LORSON RANCH EAST FILING NO. 3

STREET AND STORM SEWER  
CONSTRUCTION PLANS

SF-19-003

**STREET/STORM**  
**MUMFORD DRIVE**  
**STA 23+00 TO 27+90**

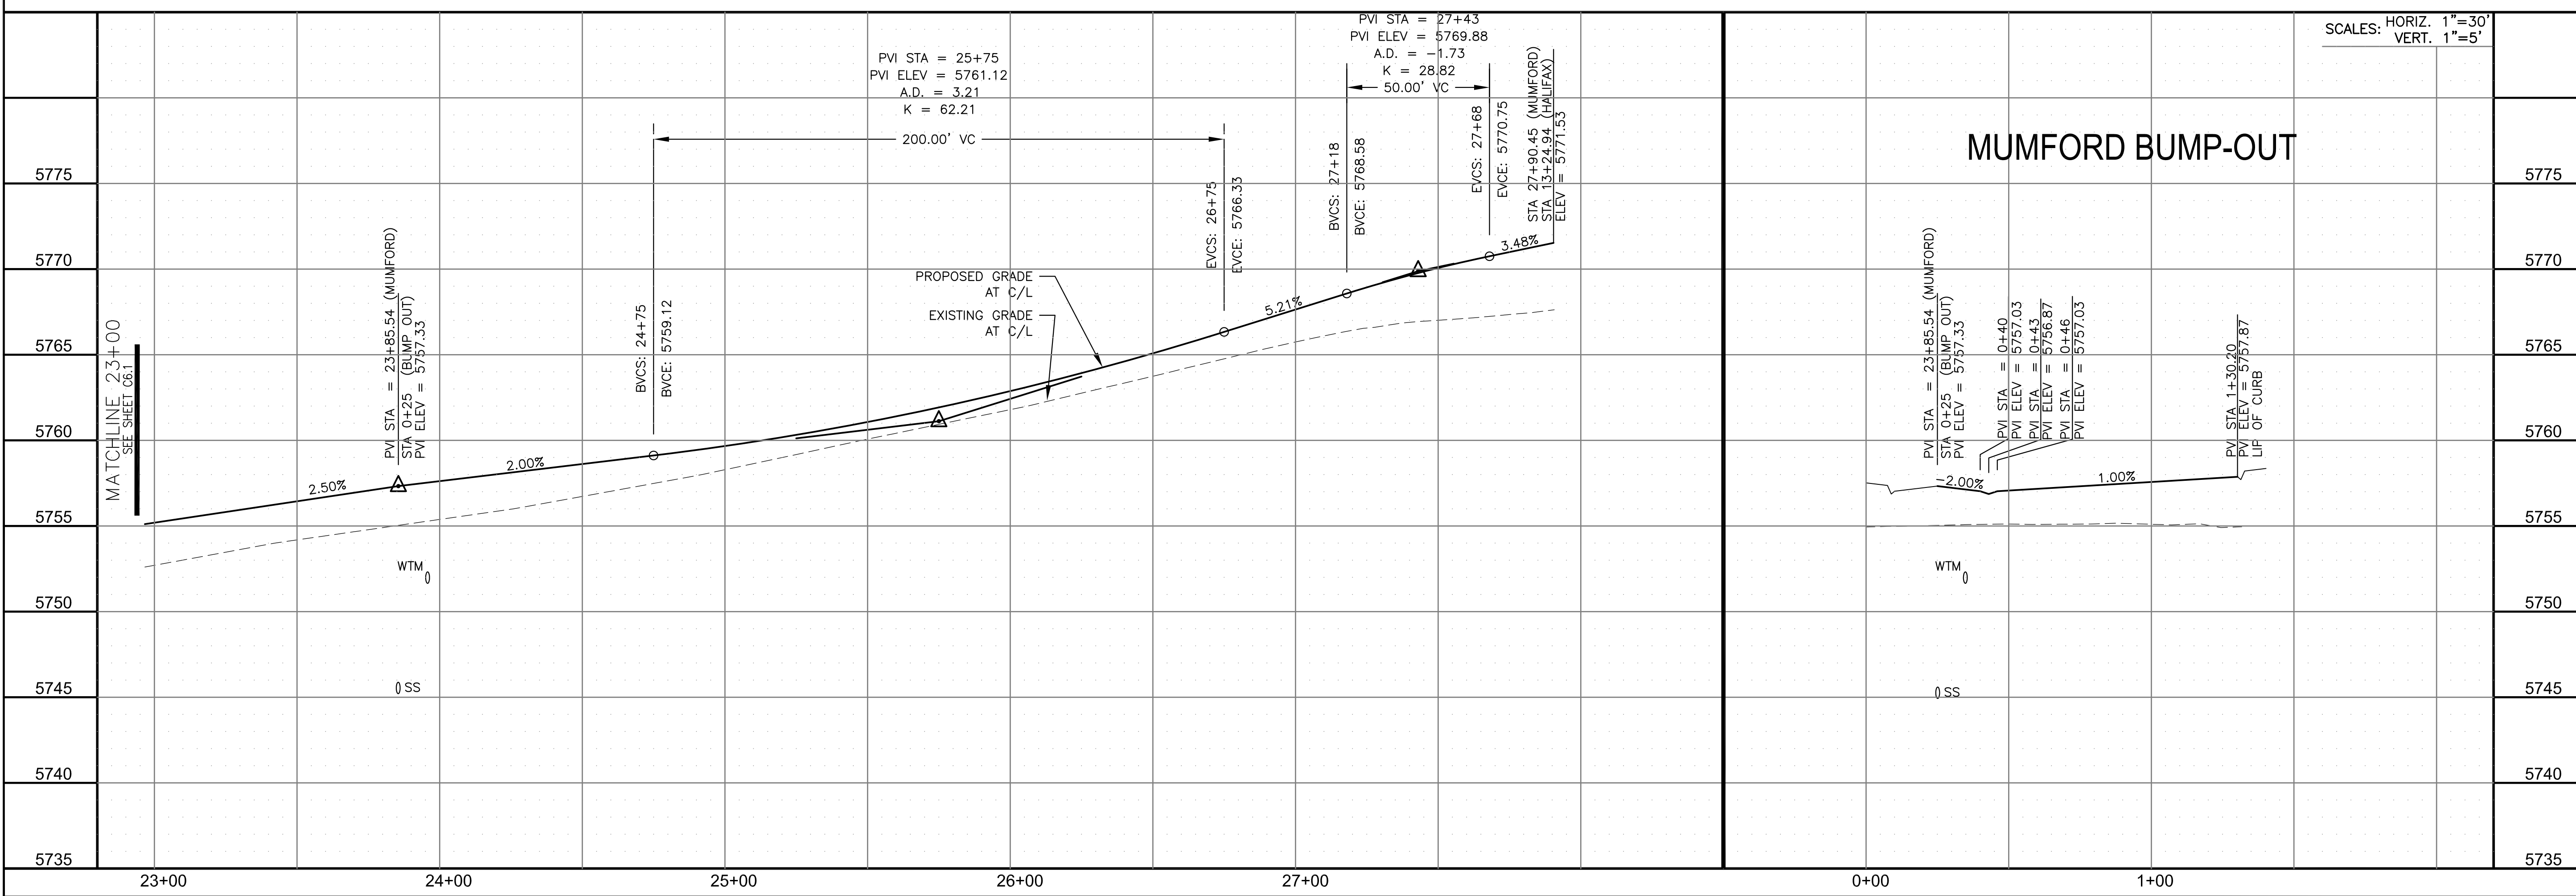
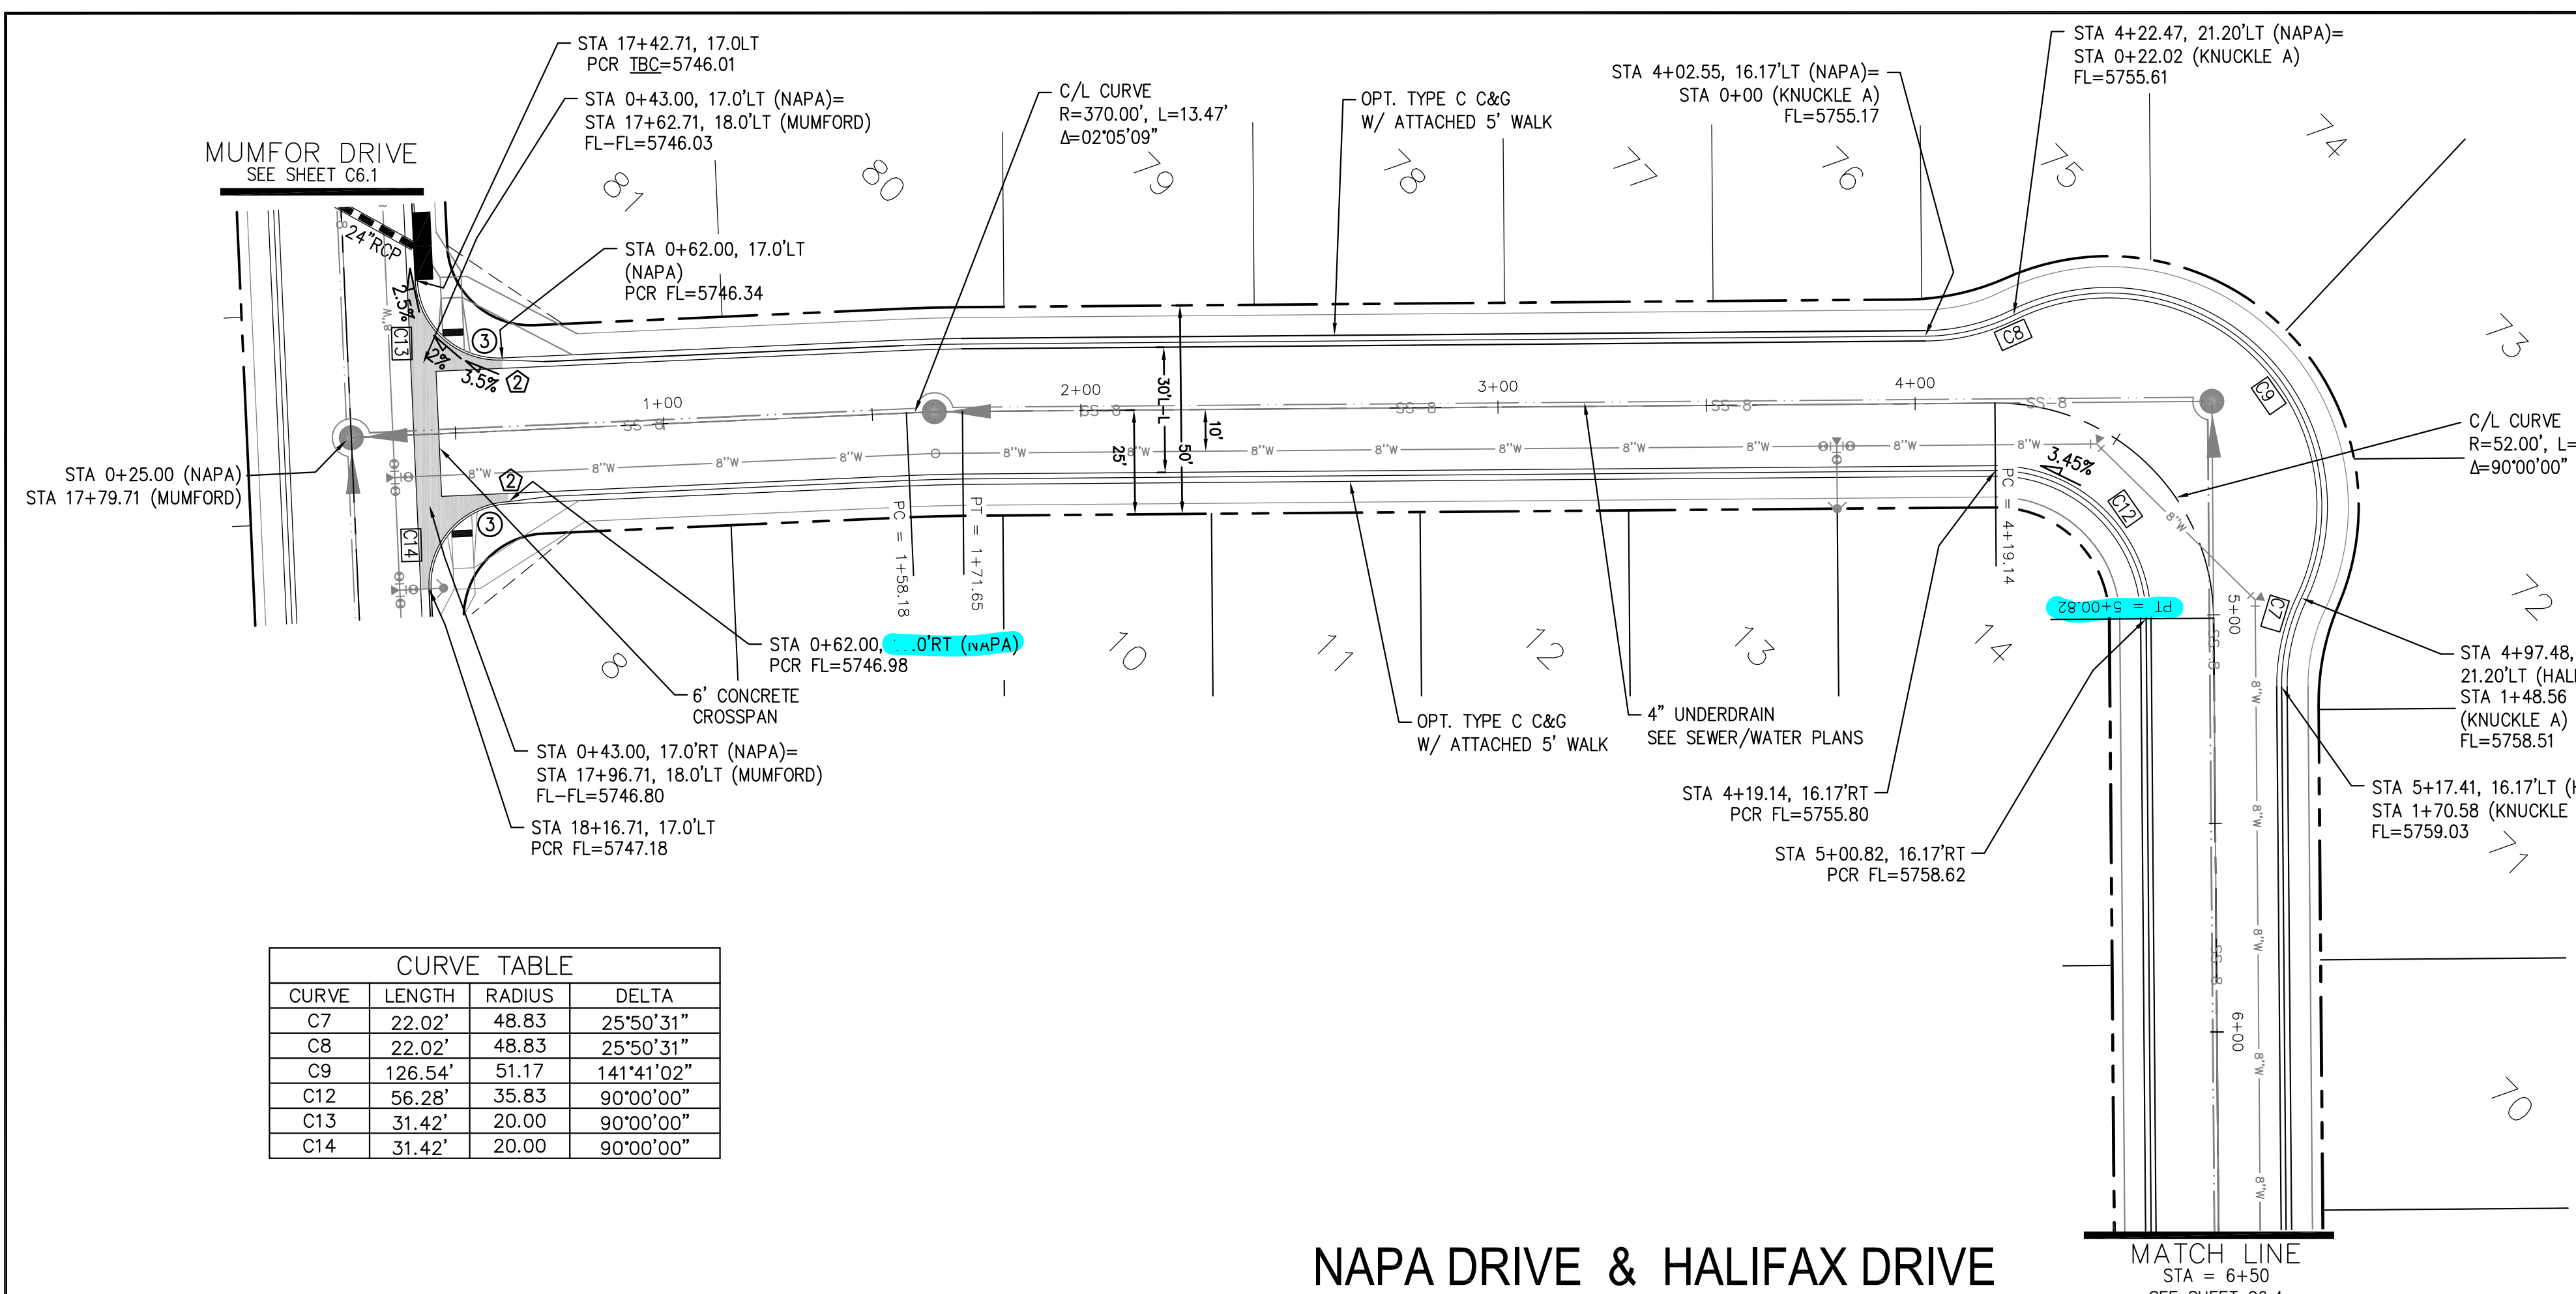
Please remove the Pedestrian ramps for crossing this "eye brow". Make the sidewalk continuous around the "eye-brow"
